PROJECT: DC Plaza - Update #2

CITY OF LAS VEGAS INTER-OFFICE MEMORANDUM		DATE: May 10, 2017
TO: Land Development Services Department of Building & Safety		FROM: Albert Sung, P.E. Flood Control Project Engineer Department of Public Works
SUBJECT:	Drainage Study for: DC Plaza – Update #2	COPIES TO: Collins Engineers, Inc.
Cross Streets:	South Corner of Farm Road & Durango Drive	Farm & Durango Investors LLC
File Number:	F:\Depot\DSMemos\DS4710E.doc	Bart Anderson, P.E., DevCo
Parcel Number:	125-17-601-007; -010; -013 & -015	NDOT
Zoning Action:	TMP-61075; VAC-61072; SUP-61071; SUP-61068; SUP-61067 & SDR-61074	
FEMA Flood Zone	YES	NO X
Proposed Storm Drain	YES	NO X

**Subject: Letter of Conformance to TDS for DC Plaza(DS #4710-1)
Collins Engineers Project No. 4136**

**Subject: Update 2 to the TDS for DC Plaza(DS #4710)
Collins Engineers Project No. 4136**

IMPROVEMENT PLANS FOR DC PLAZA
APN: 25-17-613-001
STORM DRAIN PLAN & PROFILE
 STA. 16+00.00 TO 20+54.95
 8451 FARM ROAD
 LAS VEGAS, NEVADA

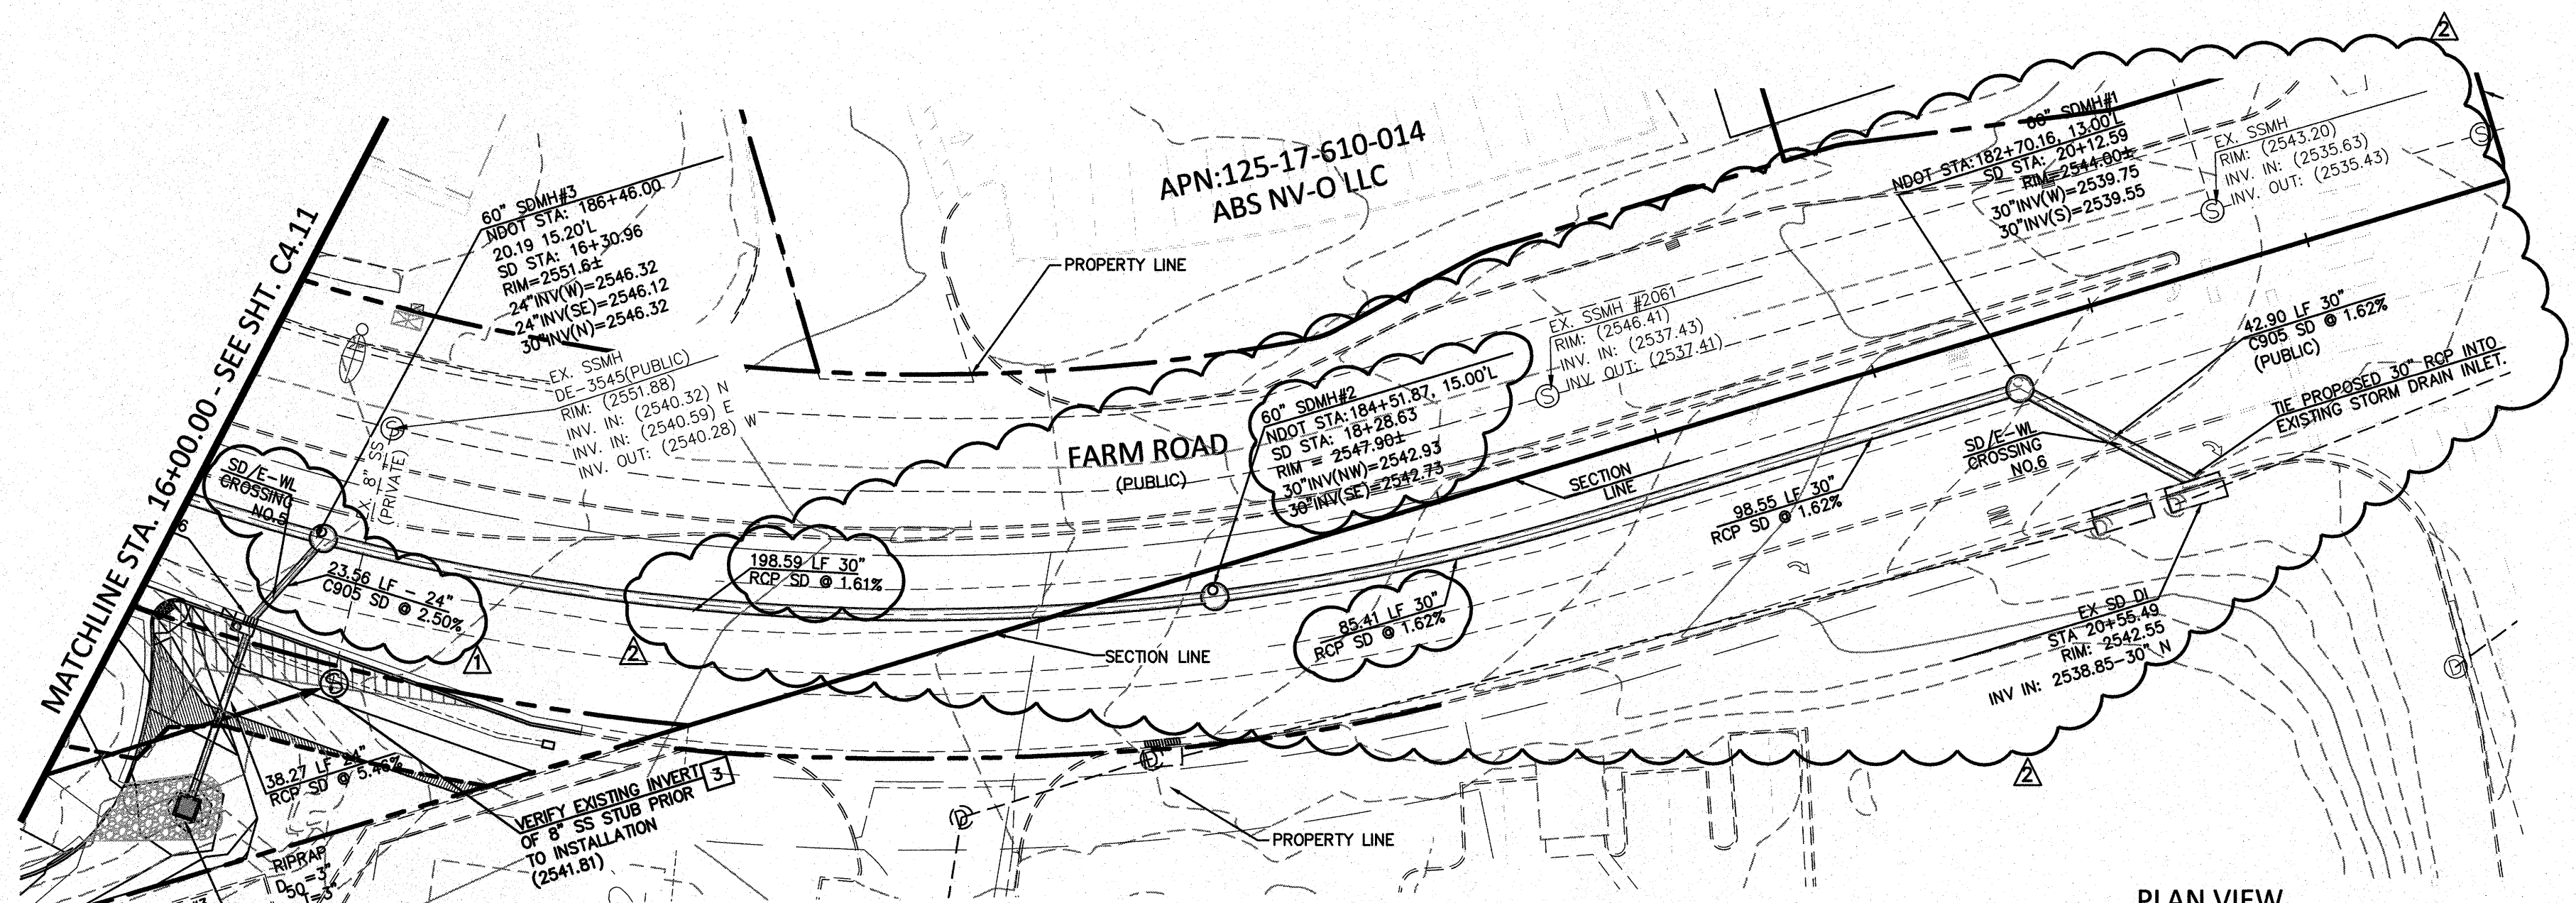
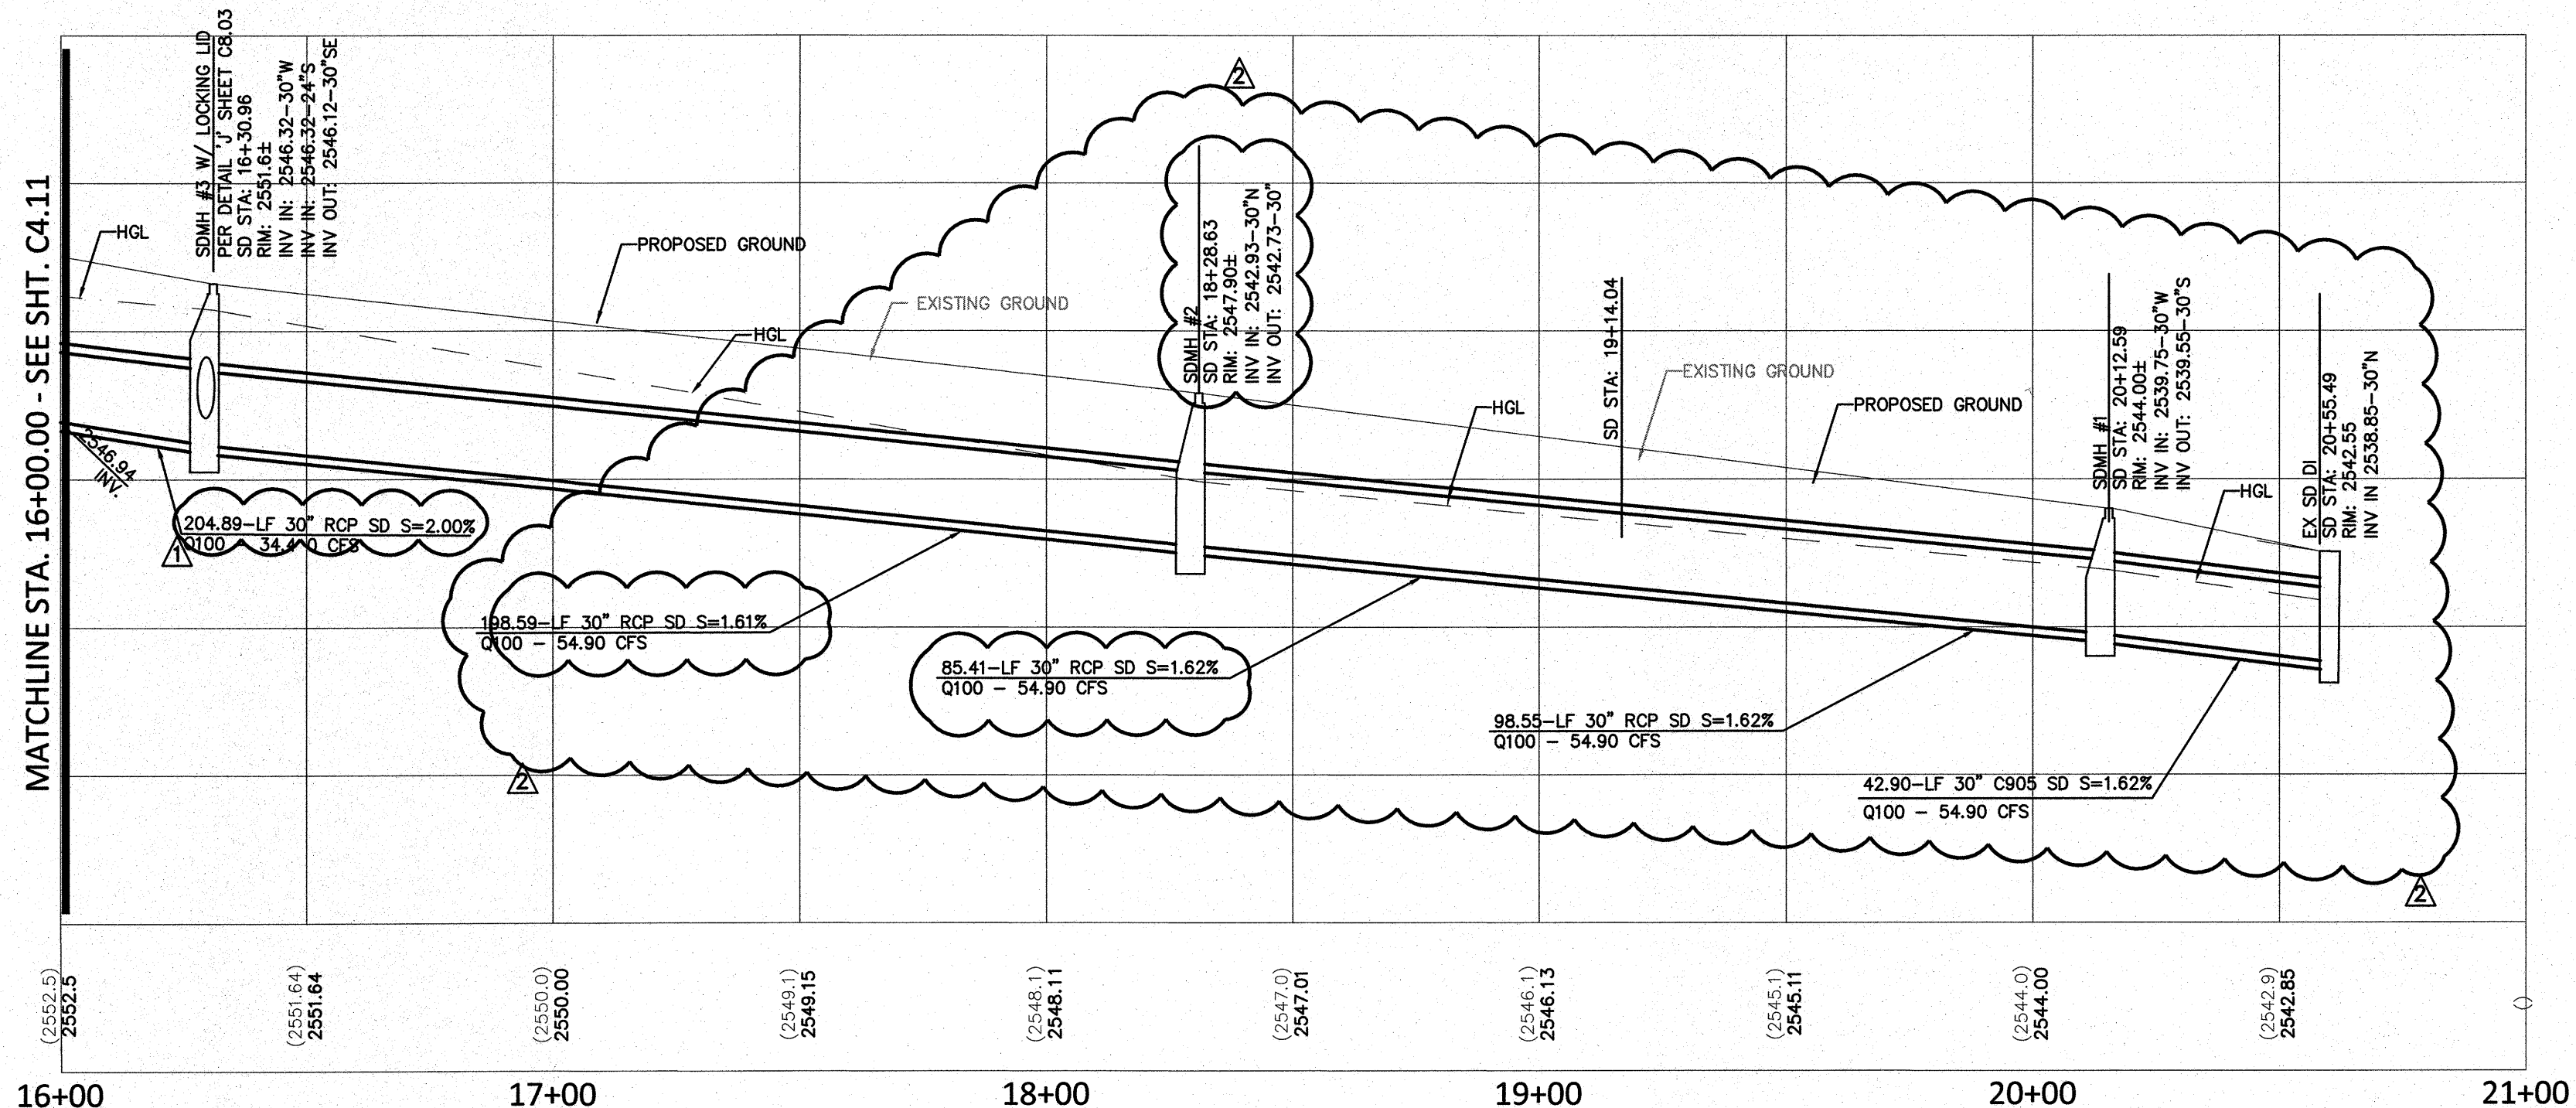
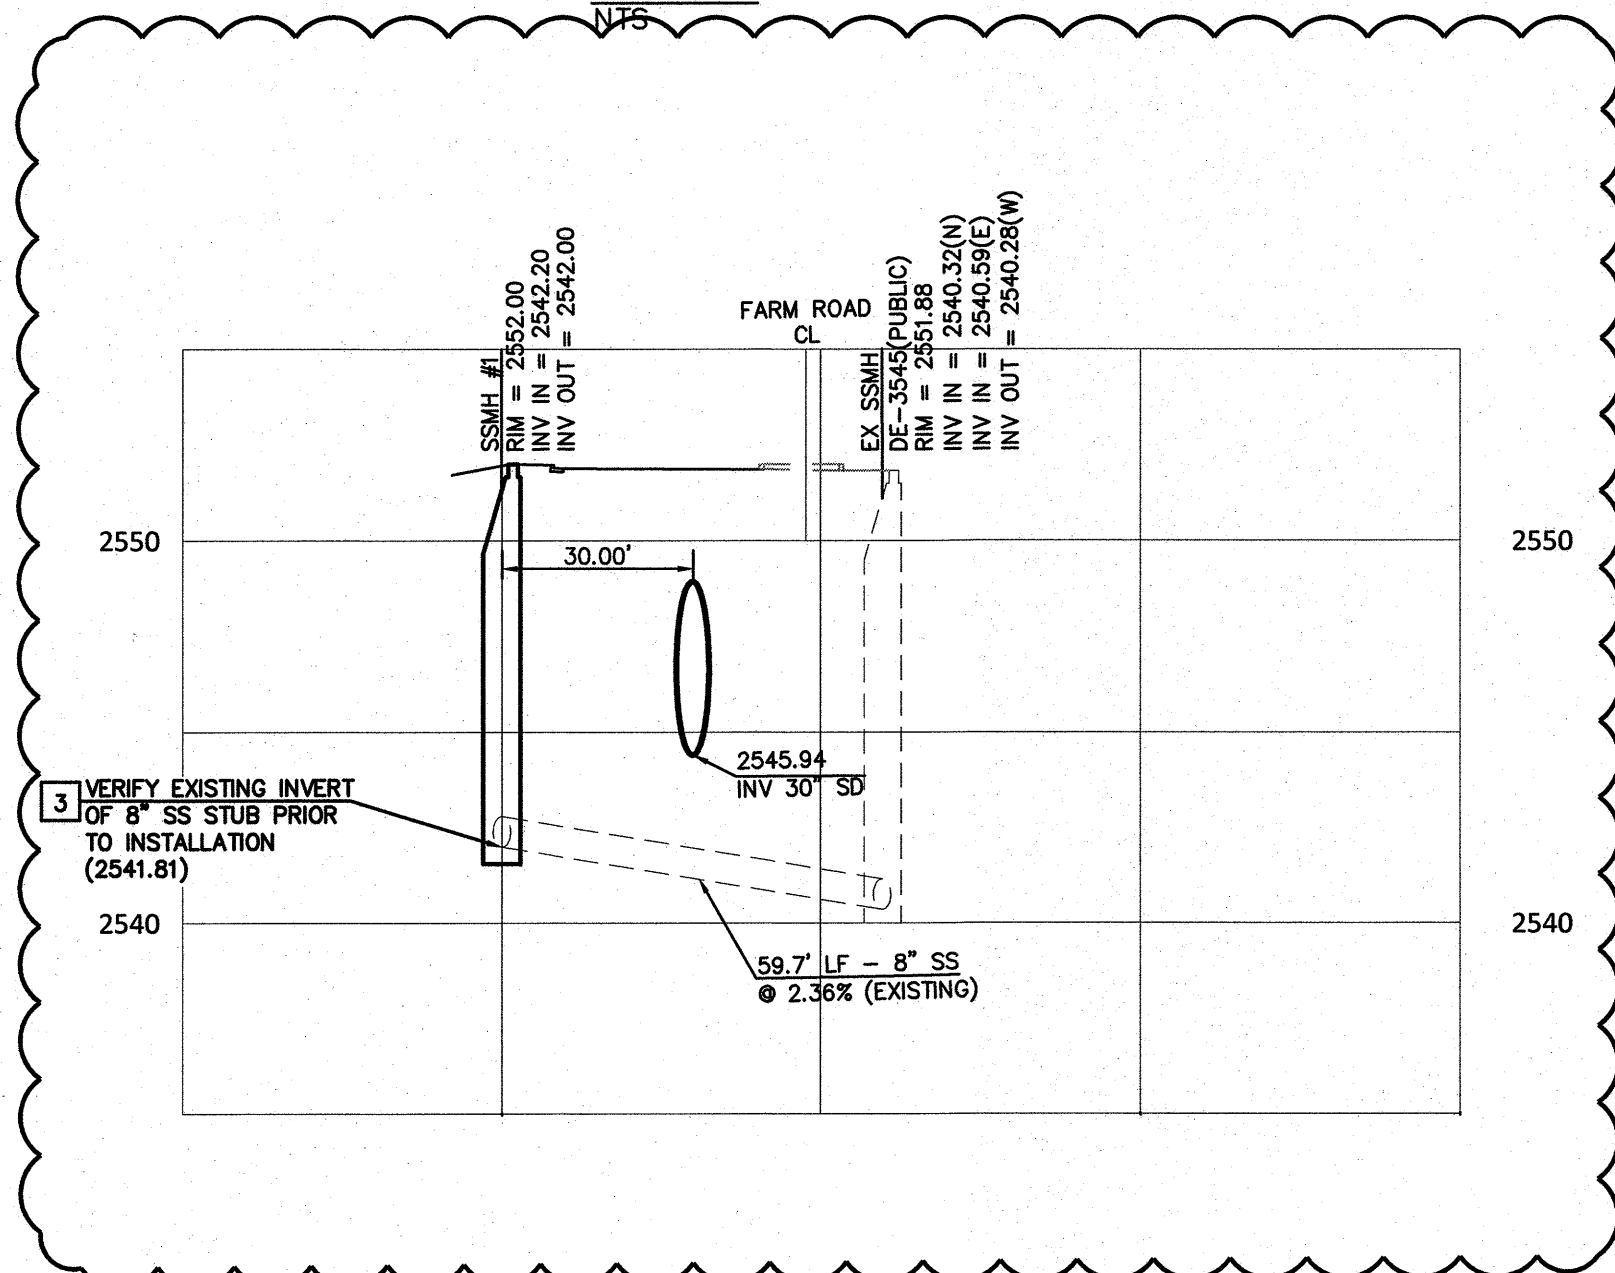
5th Submittal: Update #2 to revise slope of storm drain from SDMH #1 to SDMH #3 in Farm Road

The as-built invert elevation at the connecton location (2538.85') is 2.07' higher than the approved referenced plan, and approved drainage study. To correct this change, starting from the existing drop inlet to SDMH #3, the invert elevatons and the pipe slope have been revised.

In addition to the invert and slope changes, due to the utility conflict, the angle of connection at the end of the storm drain (from SDMH #1 to the existing Drop inlet) has been changed from 90-degree to 45-degree.

NO.	DATE	DESIGN BY	DESCRIPTION
1	03-13-17		REVISED STORM DRAIN MH#1 AND PIPES
2	05-08-17		ADDED SS CROSSING PROFILE
3			REVISED SLOPES BETWEEN SDMH#3 TO EXISTING DI PER EXISTING CONDITIONS
